<u>BNPM/OTE/207/2023-24 dated 01.08.2023</u>	BANK NOTE PAPER MILL INDIA PRIVATE LIMITED	
	<u>CORRIGENDUM No. 1</u> <u>SUPPLY OF CERAMIC COATED TEFLON ROLLS AT BNPM PLANT, MYSURU</u>

CORRIGENDUM No. 1 DATED 04.08.2023

BNPM/OTE/207/2023-24 dated 01.08.2023.

PURCHASER	:	BANK NOTE PAPER MILL INDIA PRIVATE LIMITED
MATERIAL	:	SUPPLY OF CERAMIC COATED TEFLON ROLLS AT BNPM PLANT, MYSURU
LOCATION	:	BNPM PLANT, MYSURU, KARNATAKA

BANK NOTE PAPER MILL INDIA PRIVATE LIMITED MYSORE-570003			
	SIGNATURE	DATE	Security Thread Carrying Roller With Ceramic Coating And End Covers
PREPARED BY	N Gupta	12/11/22	
CHECKED BY	Abhishek kr	12/11/22	MOC: Aluminium
APPROVED BY	Nitesh kr	12/11/22	DRG.NO:BNPM/PMP/ 006/2022-23

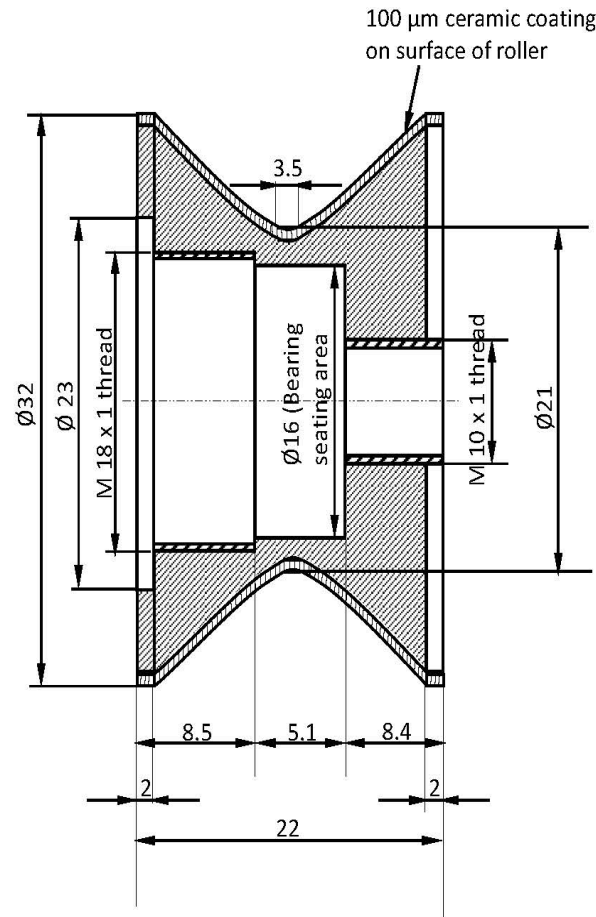
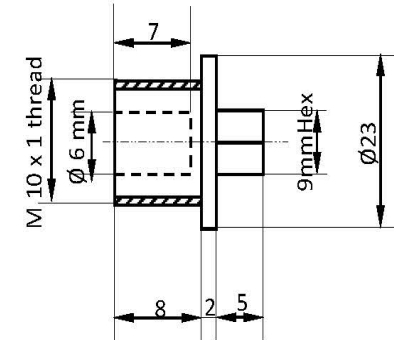
S. No.	Item Description as per tender	To be read as
1	<p>Supply of Ceramic Coated Teflon Roll 10.35-1040.A2</p> <p>as per drawing at BNPM, Mysore</p> <p>MOC: Aluminum</p> <p>(As per drawing DRG.NO:BNPM/PMP/006/2022-23)</p>	<p>Supply of Ceramic Coated Teflon Roll 10.35-1040.A2</p> <p>as per drawing at BNPM, Mysore</p> <ul style="list-style-type: none"> • MOC: Aluminum • Thread carrying roller with ceramic coating along with end covers as per DRG No 006 BNPM/PMP/006/2022-23 must be supplied with Security Thread Carrying Roller Shaft as per DRG No BNPM/PMP/ 005/2022-23 (enclosed) • Thread carrying roller must be assembled together with roller shaft and bearing (625 ZZ, SKF make or equivalent) • Each roller assembly consist of Thread carrying roller, Roller Shaft, End covers (Front and Back end cover) and bearing (625 ZZ, SKF make or equivalent). • Vendor must fill the water resistant grease from both end in order to avoid the water ingress.

ii) Ref Drawings No. BNPM/PMP/006/2022-23 & BNPM/PMP/ 005/2022-23 enclosed
